SERVICE LETTER

SUBJECT: COCKPIT DOOR LATCHING MECHANISM MODIFICATION
INSTRUCTIONS

MODELS AFFECTED: All McDonnell Douglas Helicopter Systems (MDHS) MD900 series helicopters, serial numbers up to and including 900-00040, that have not been modified at MDHS.

Figure 1. Door Latching Mechanism Removal

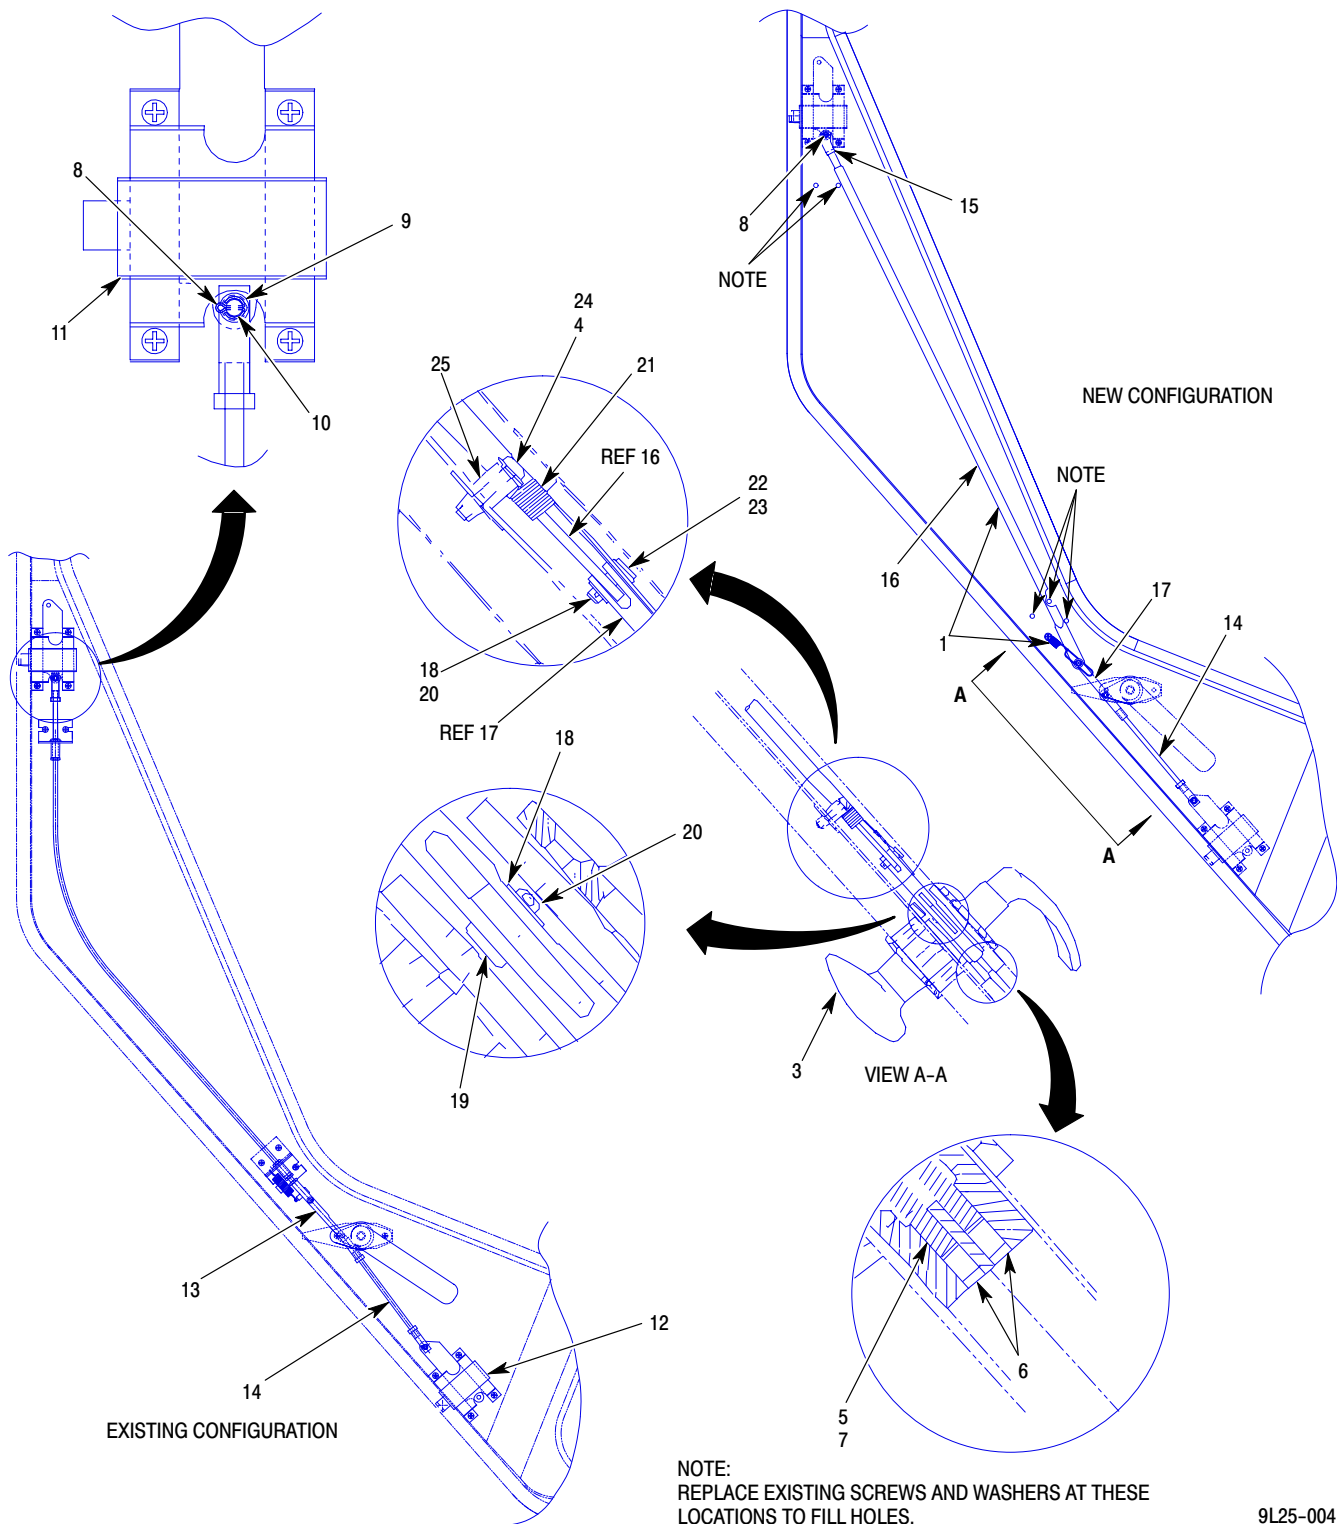
- C. Description:** Procedures in this Letter provide operators with instructions to modify the existing Cockpit Door Latching Mechanism, P/N 900F3305181-101/-102 to the upgraded configuration, P/N 900F3305187-101/-102 .

- A.** Remove screws that attach entire latching mechanism (1) to door structure (including screws from outside door handle assembly (3)).

- B.** Remove compression springs (5) from door handle (3) by releasing screws (6).
- C.** Replace springs (5) with replacement compression springs (7) and secure with existing screws (6).
- D.** From upper latch block assembly (11), remove and discard cotter pin (8). Remove and retain washer (9) and clevis pin (10).
- E.** Except for that of the lower latch block assembly (12), remove and discard remainder of cotter pins (8).
- F.** Remove and retain remainder of washers (9) and clevis pins (10).
- G.** Remove link (13) from upper end of lower push/pull rod (14).
- H.** Install clevis (15) onto connecting tube (16).
- I.** Attach to upper latch block (11) using washer (9) and clevis pin (10). Install new cotter pin (8).
- J.** Install LH clevis (17) onto upper end of lower push/pull rod (14).

- K.** Attach to door handle assembly (3) using washer (18) and clevis pin (19). Install new cotter pin (20).
- L.** Attach clevis (17) to connecting tube (16) and extension spring (21) using clevis pin (22) and washers (18 and 23). Install new cotter pin (20).
- M.** Re-install modified latching mechanism (1) to door structure using original screws.
- N.** Secure extension spring (21) to door structure in remaining unused hole using screw (24), spacer (25) and washer (4).
- O.** Verify door latching mechanism operation per revised rigging instructions document provided with door modification kit.
